Access Compliance Report

Public Rights-of-Way

(Curb Ramps)

Intersection ID: 10035049	Main Street: PROVIDENCE_RD	Cross Street: N/A	Location: NE
ADA ID: D865D6E64065	Ramp Type: Directional1	Initial Pass/Fail: Fail	Overall Compliance: No
Severity Score: 1.25			
Codes/Mitigation Info/Possible Solution		Field Measurements/Component Compliance

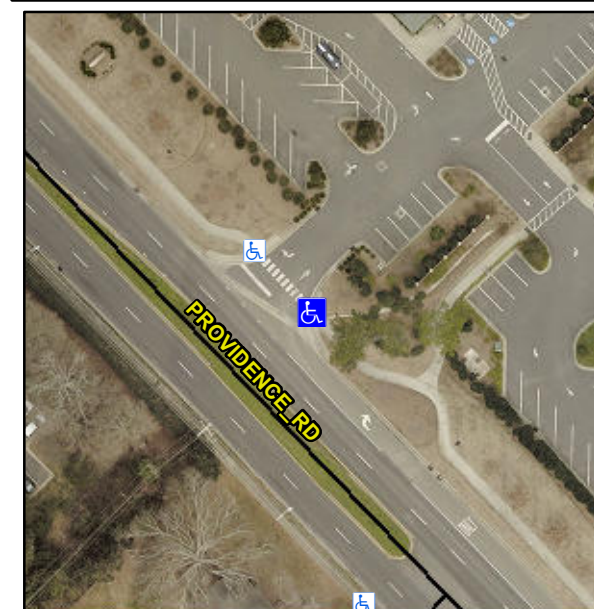
R304.5.3

Compliance	Description	Data	Compliance	Description	Data
N/A	Ramp Length (in)	119.0	N/A	Grade Break?	N/A
Yes	Ramp Width (in)	69.0	N/A	Grade Break Slope (%)	0.0
Yes	Ramp Slope (%)	2.5	N/A	Grade Break XSlope (%)	0.0
No	Ramp XSlope (%)	2.2			
N/A	Flare Type LT	N/A	N/A	Flare Type RT	N/A
N/A	Flare Slope LT (%)	N/A	N/A	Flare Slope RT (%)	0.0
N/A	Flare Traversable LT?	N/A	N/A	Flare Traversable RT?	N/A
N/A	Landing Length (in)	0.0	N/A	DWS Provided?	N/A
N/A	Landing Width (in)	0.0	N/A	DWS Contrast?	N/A
N/A	Landing Slope (%)	0.0	N/A	DWS Length (in)	N/A
N/A	Landing X Slope (%)	0.0	N/A	DWS Full Width?	N/A
N/A	Landing Curb? (Y/N)	N/A	N/A	DWS Offset LT (in)	N/A
N/A	Shared Landing?	N/A	N/A	DWS Offset RT (in)	N/A
N/A	Gutter Ponding?	0.0	N/A	Gutter Slope (%)	N/A
N/A	Gutter Lip Ht (in)	0.0	N/A	Gutter X Slope (%)	N/A
N/A	Painted X Walk1?	Yes		Road Slope (%)	5.1
	X Walk 1 Direction	To NW		Road X Slope (%)	3.5
	X Walk 1 Width (in)	60.3		Clear Space?	N/A

Remove & Replace Entire Ramp.
